Beyondie Potash Project

Ten Mile Impact Assessment

22 August 2018

Project No: 201320-14624 – Beyondie Potash Project: Ten Mile Impact Assessment

Figure 5-4: Projected surficial aquifer drawdown at Year 23 at 150 ktpa SOP Production

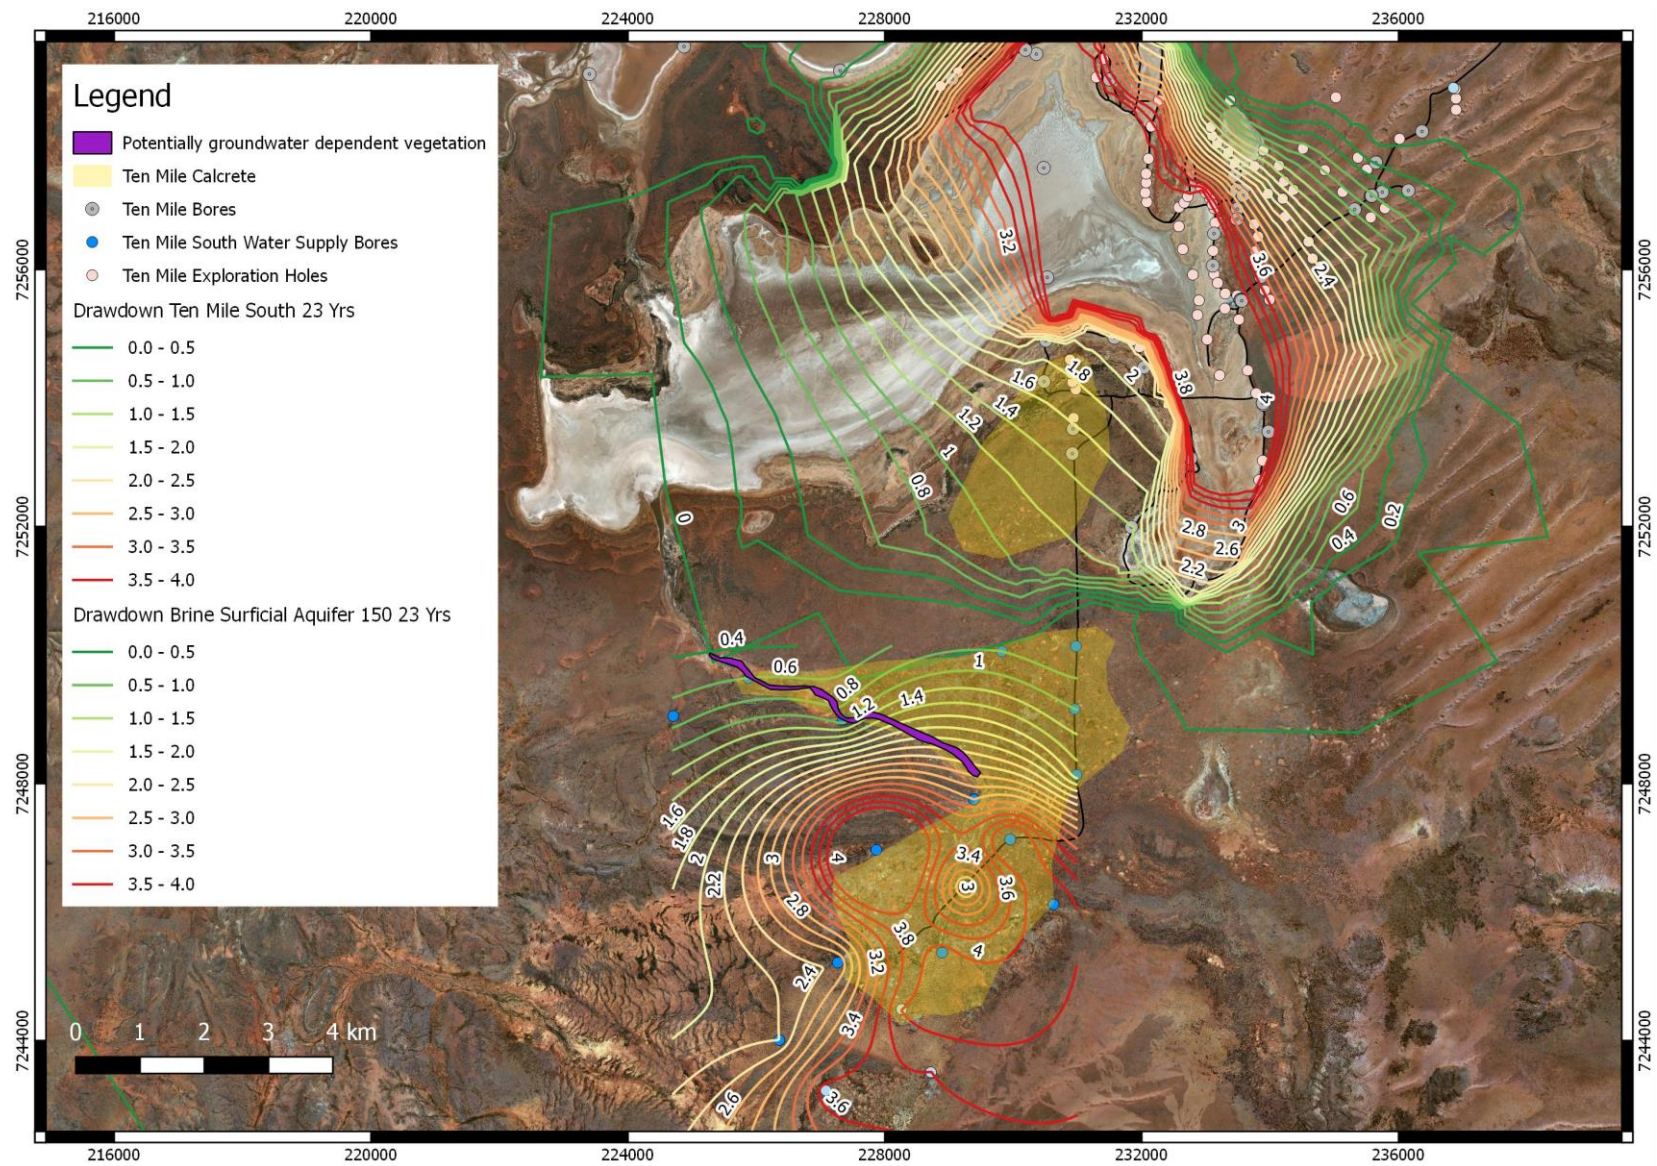
- DWER Comment: Abstraction from trenches in the Ten Mile Lake surficial aquifer (Figure 7-8 (Advisian 2017)) have predicted maximum drawdown impacts of about 0.5 to 1.5 m in areas where investigations indicate the groundwater in calcrete bodies is brackish to fresh. Acceptable impacts on potential stygofauna in this area will need to be formally evaluated now for the later stages of the project and then monitored as the project proceeds.

- Response:
 - The predicted interactions between the two abstractions appears to be minimal for up to the 150 ktpa production scenario (Figure 5-4). In addition, the 150 ktpa scenario has zero recharge and is therefore considered highly conservative.

- Additional monitoring has been proposed in all surficial monitoring bores. Trigger levels have been proposed based on the Ten Mile South Water Supply H3 Report (Advisian 2018), which maintains between 60 and 70% of the aquifer thickness in the calcrete over the life of mine.

- Stygofauna monitoring has been proposed on an annual basis for the first two years of operation to characterise the communities and quantify impacts. After the additional sampling and operation drawdown responses it is proposed to re-visit the trigger levels and ongoing monitoring program.
